Delegated Planning Committee Meeting Agenda

Delegated Planning Committee Meeting Agenda

1. Refuse to grant a planning permit under the provisions of the Hobsons Bay Planning Scheme for Planning Application PA220336 in respect of the land known and described as 1 Hudsons Road, 1 Booker Street and 30 Craig Street, Spotswood on the grounds contained in the Draft Refusal Grounds in Appendix 2.
2. Delegate the authority to settle any matter before the Victorian Civil and Administrative Tribunal (VCAT) which may arise to the Council's Manager Planning, Building and Health.

1. Refuse to grant a planning permit under the provisions of the Hobsons Bay Planning Scheme for Planning Application PA220337 in respect of the land known and described as 1 Hudsons Road, 1 Booker Street and 30 Craig Street, Spotswood on the grounds contained in the Draft Refusal Grounds in Appendix 8.
2. Delegate the authority to settle any matter before the Victorian Civil and Administrative Tribunal (VCAT) which may arise to the Council's Manager Planning, Building and Health.

Figure 3: Proposed layout of building, Source: Architectural plans (TP400 Rev A) by Six Degrees Pty Ltd

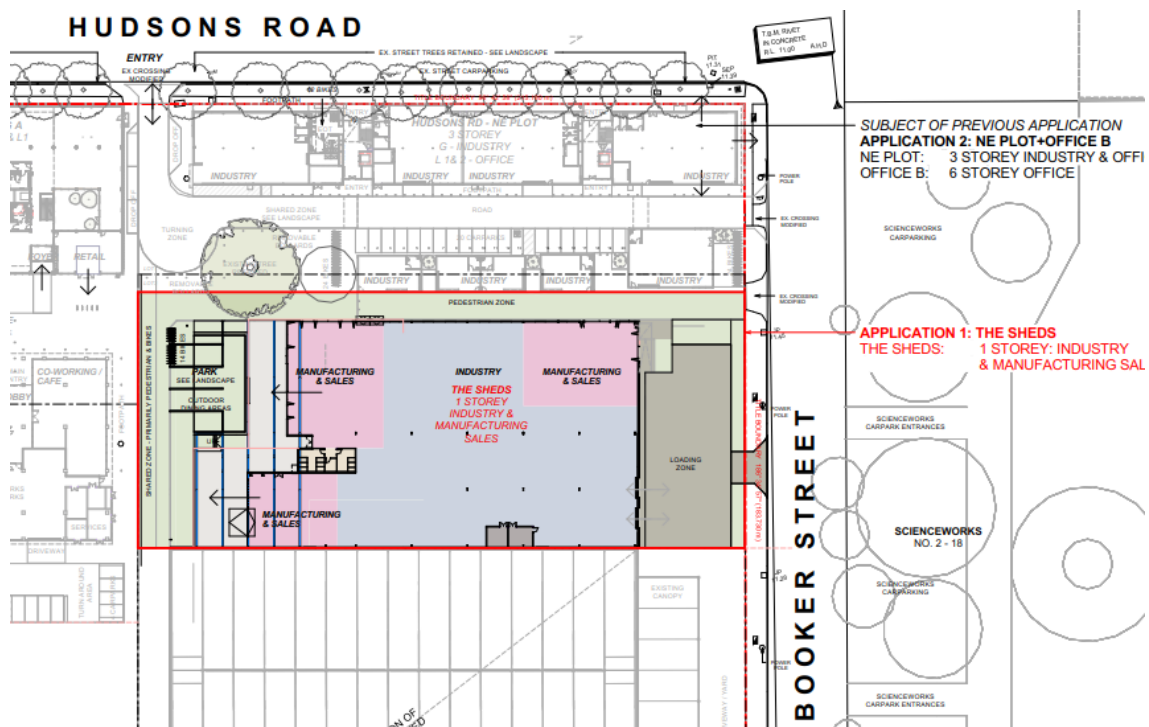
The proposed uses do not appear to have been adequately described because the proposal includes significant areas of front of house dining areas and live music which would seem to go beyond what is envisaged to be “manufacturing sales”. These activities might be best defined as a “food and drink premises” and “bar” under the Planning Scheme definitions, and as such, would trigger additional use permission, noting all three land uses fall within the ambit of a “retail premises” which is a Section 2 use in the Industrial 1 Zone. Whilst nothing turns on these additional triggers, it is necessary that the use of the land is properly described.

The areas shaded pink below indicate the manufacturing sales area and the light grey colour indicates the industry use. The area on the west side of the building will form an outdoor dining area with a stage for live music.

Figure 8: Proposed parking arrangements, Source: Architectural plans (TP400 Rev A) by Six Degrees Pty Ltd

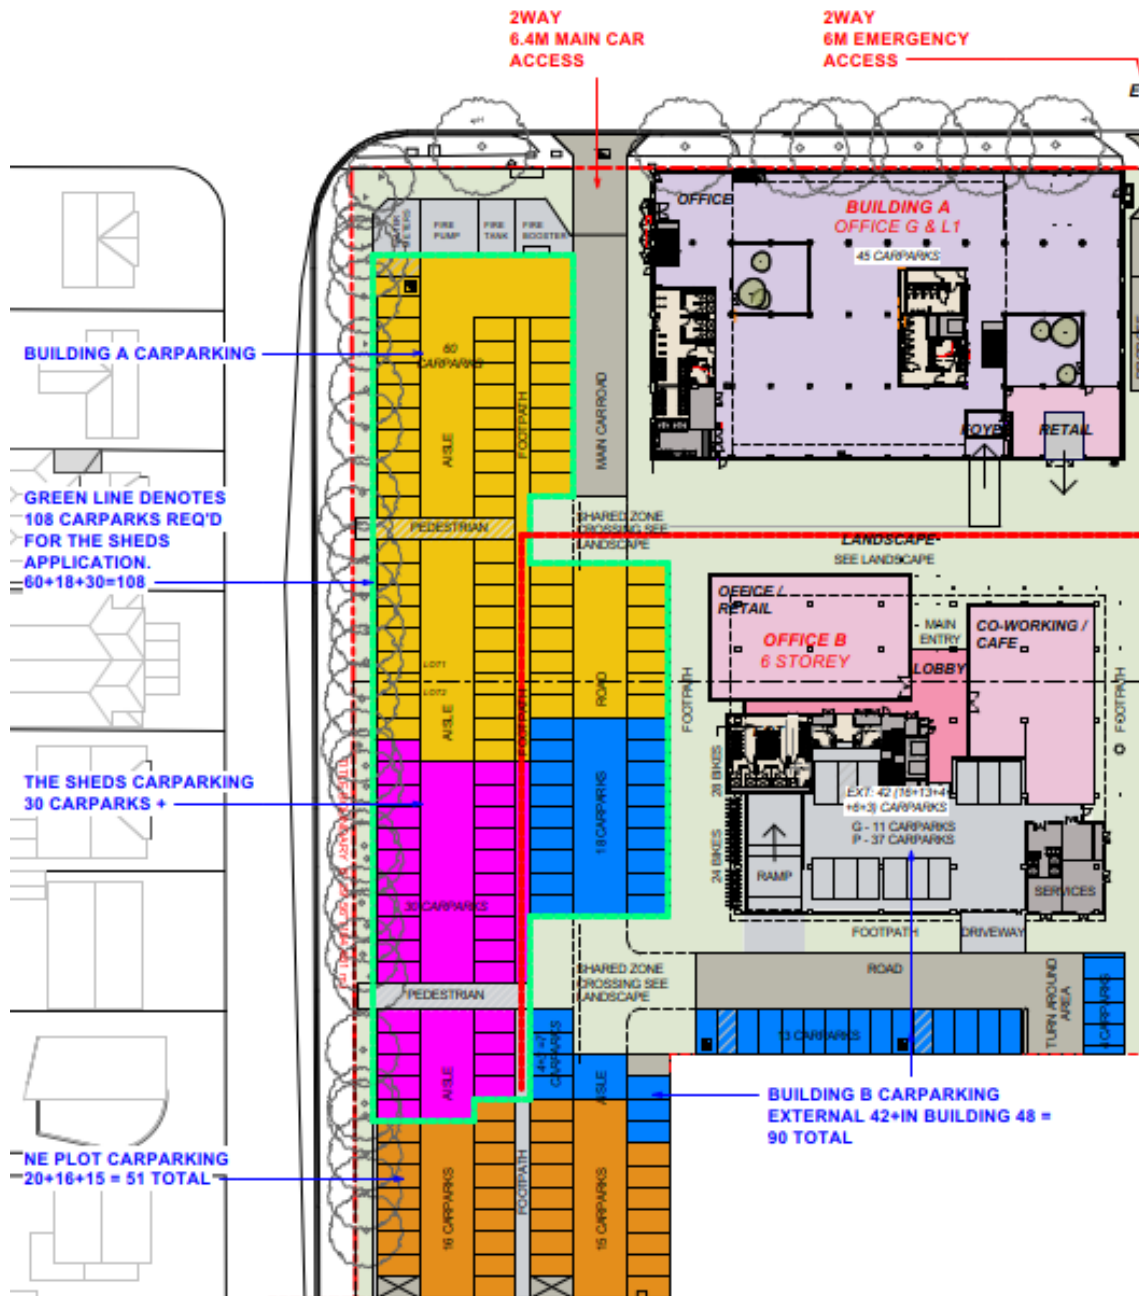
The interim arrangement comprises 30 dedicated spaces (coloured pink) during the daytime hours, increasing to 108 spaces during evenings and weekends by using the pool of 60 spaces provided for Building A (PA210239) (coloured gold) plus 18 spaces shared with Office B (coloured blue) that exists currently.

Figure 14: Ultimate arrangement for The Sheds, Source: Site Plan – proposed masterplan (TP004 Rev A) by *Six Degrees Pty Ltd*

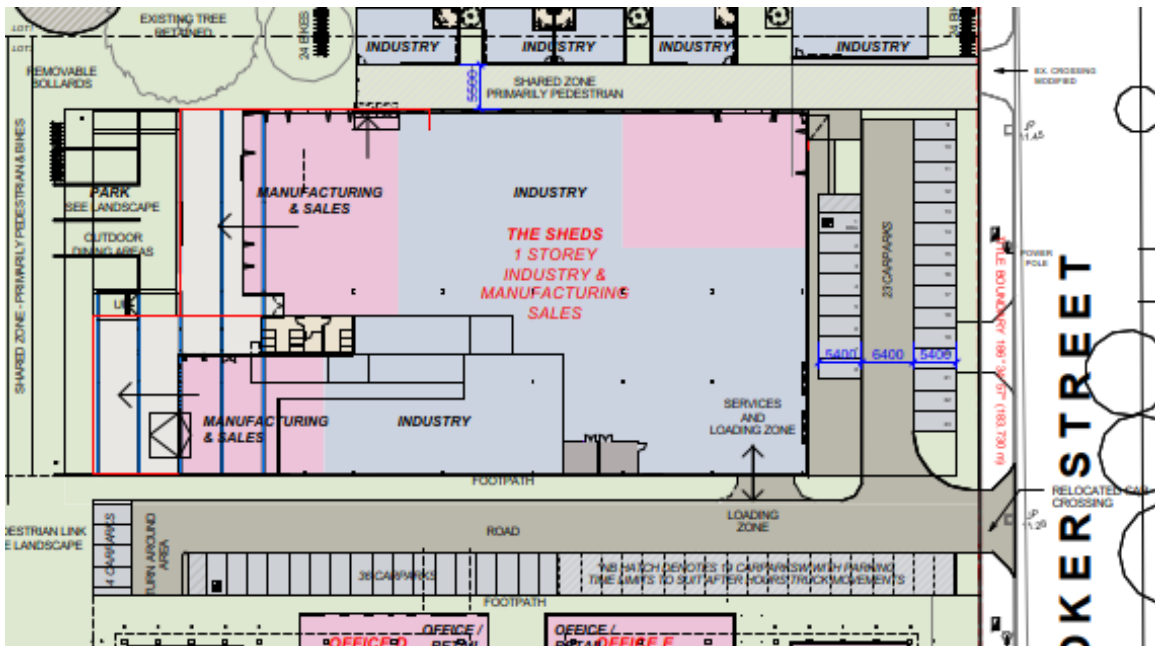
These are fundamental concerns.

Figure 21: Trees to be removed, Source: Oculus, *Application 1, The Sheds, Spotswood Precinct, July 2022*

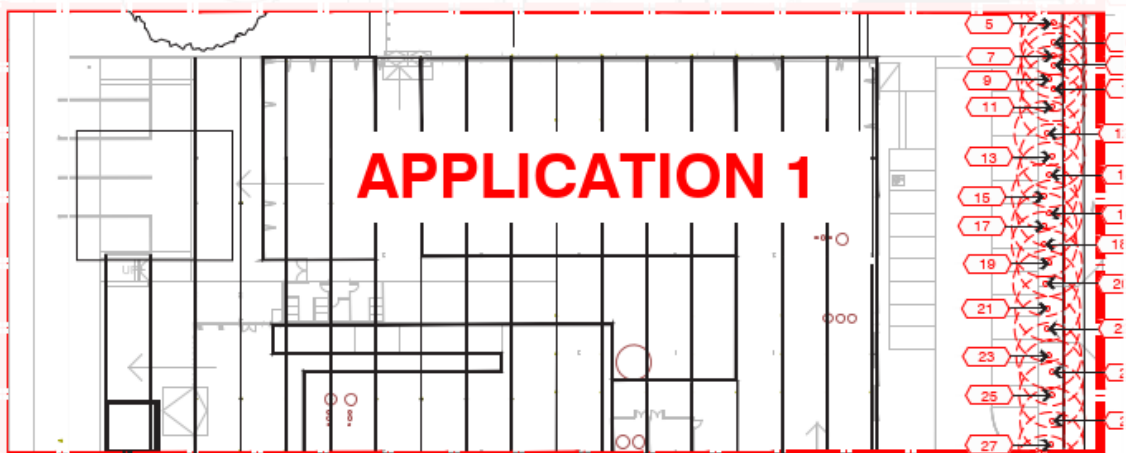
The application shows the removal of the row of trees along Booker Street, replaced with a landscaped buffer comprising native species:

Car parking allocation plan

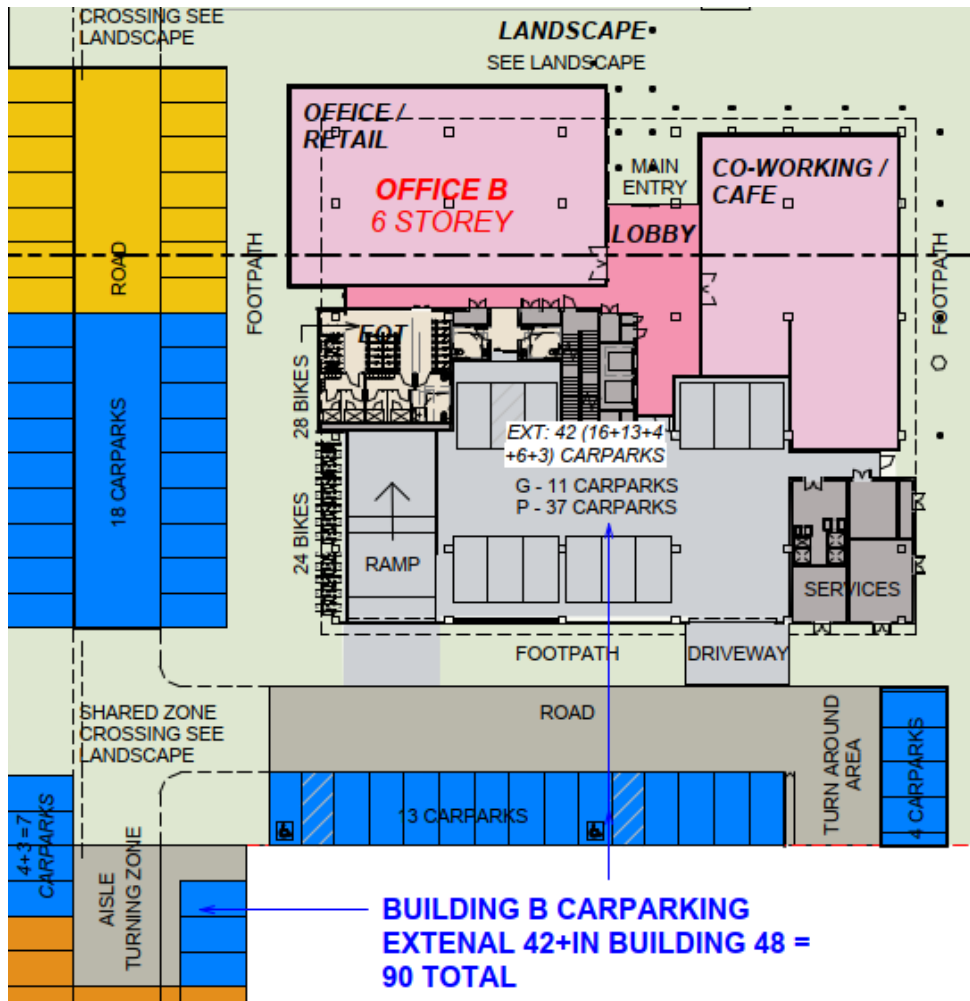
The applicant traffic and transport assessment has assumed 42 spaces and therefore this is what the assessment will be based on. If a permit is granted, a condition would be necessary to ensure that 42 spaces are shown on any plans.

Figure 27: Location of entry to T4, Source: North East Plot Proposed Ground Floor Plan TP100 Rev B by *Six Degrees Pty Ltd*

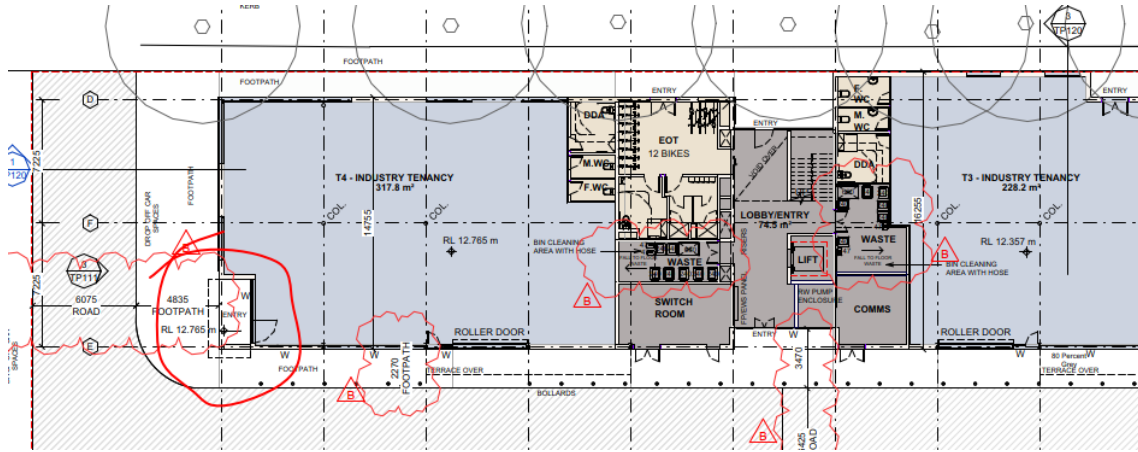
The application was referred to Council’s Urban Design consultant who supports the North East building complex but has questioned the positioning of the entry to Tenancy T4 not being visible from the street (but that otherwise the entries are logical). Notwithstanding the comments of the Urban Designer, the entry is considered acceptable because it is located on a wide footpath which combined with the accessway will have clear visibility from Hudsons Road. Refer below:

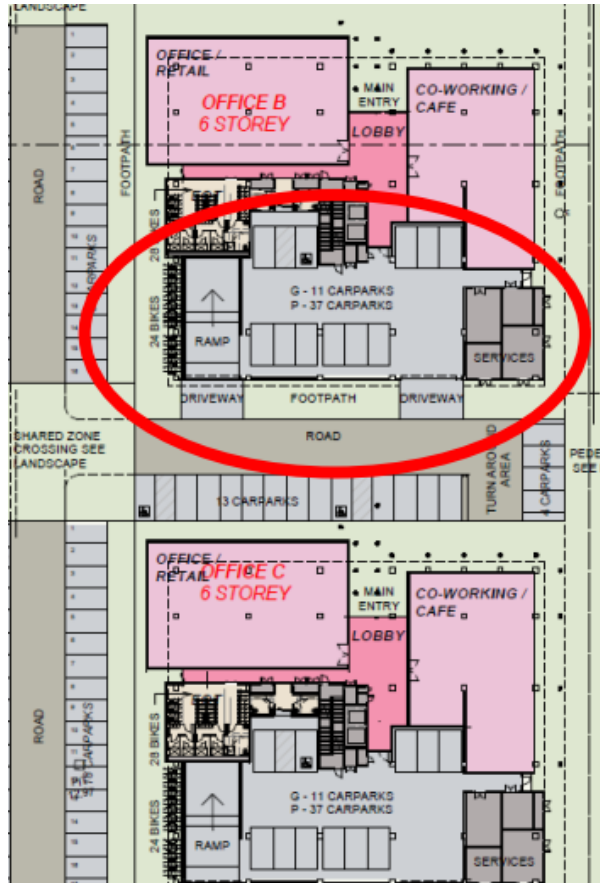
included on the plans. If a permit is issued, a condition would need to be applied to show all areas which the particular stage relies on.

The key issue of concern relates to the inclusion of the multi-level car park within Office B which results in an inactive service zone on the south side at ground level facing the corresponding front door of a later stage of development:

Figure 29: North façade (note extent of glazed openings), Source: North East Plot Proposed Elevations and Materials TP110 Rev A by *Six Degrees Pty Ltd*

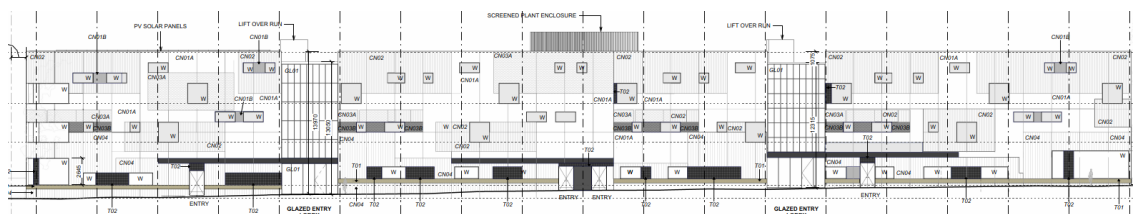
A matter not cited in the urban design comments is the façade treatment of the northern elevation of the industry/office tenancies in the North East Plot. The northern façade contains many openings and will be exposed to direct sun and light, but does not contain any shading devices or measures to manage this issue.
